Title: REPORT ON CALLED-IN PLANNING

CAIRNGORMS NATIONAL PARK AUTHORITY

**DEVELOPMENT PROPOSED:** Amended route of temporary haul road

**REFERENCE:** 2015/0316/DET

Figure 3: Proposed New Route of Haul Road

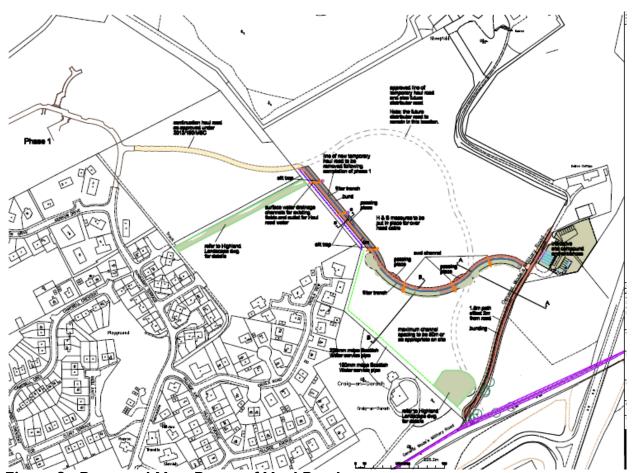
10. The applicants now wish to amend the line of this construction road, as shown in Figure 3 which illustrates the route of the originally approved road (dashed line) and the currently proposed one (in red) for ease of comparison with Figure 2.

Figure 4: Upgraded junction onto A86

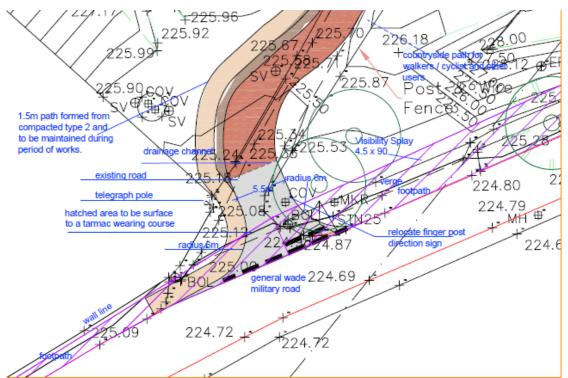
11. This new route will use the exiting private track junction onto the A86 Aviemore to Kingussie Trunk Road, using the exiting track/core path (General Wade road) which leads to Kerrow Farm and Kerrow Cottage for around 200 metres before heading northwest to join the originally approved route for Phase I. A I.5 metre wide footpath is proposed beside the existing track to allow for separation of pedestrian and vehicular traffic on this core path. The junction of the access onto the A86 will be upgraded to enable two vehicles to pass, together with some radii improvements, footpath provision and provision of visibility splays. This proposed junction arrangement is shown in **Figure 4** and the dashed line shows the existing route of the General Wade Road.

Figure 6: Advance planting originally proposed

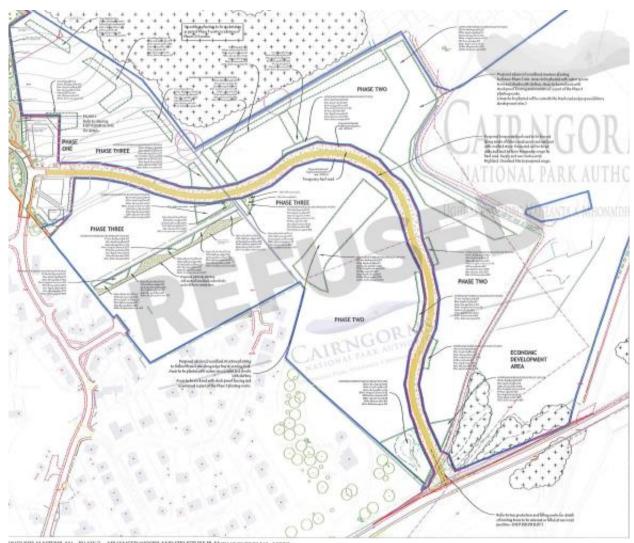
- 20. At the time of consideration of the 2013 MSC application, the applicants submitted a proposal for advance planting which formed the basis of the landscape plan which was to be provided in fulfilment of condition 7. Figure 6 shows the applicants proposed advance planting in the vicinity of the haul road location as proposed at that time. The areas outlined in green identified for advance planting.

Figure 7: Planting currently proposed

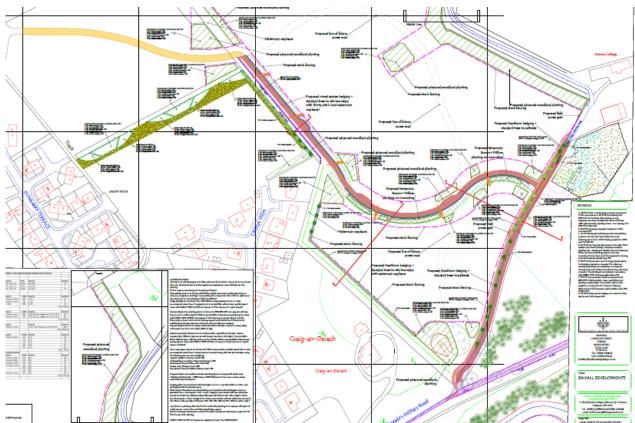
- 21. The agents suggest amended wording for this condition in the accompanying application 2015/0317/DET to reflect their view that there is now no need to undertake the same level of advance planting given that the revised haul route will have less visual impacts.
- 22. With the current haul road application under consideration, the applicants initially proposed only planting in the former borrow pit to the west of the access point, some limited planting alongside the new haul road and to the north of the shinty pitch. Following ongoing discussion they have now agreed to increase the level of advance planting to include areas alongside the haul road, to the north alongside the track to Kerrow Farm, alongside the boundary to Craig an Darach, and increased planting to the Croila View boundary. This is as shown in **Figure 7**.

52. All new development proposals require to be assessed in relation to policies contained in the adopted Local Development Plan. The full wording of policies can be found at:
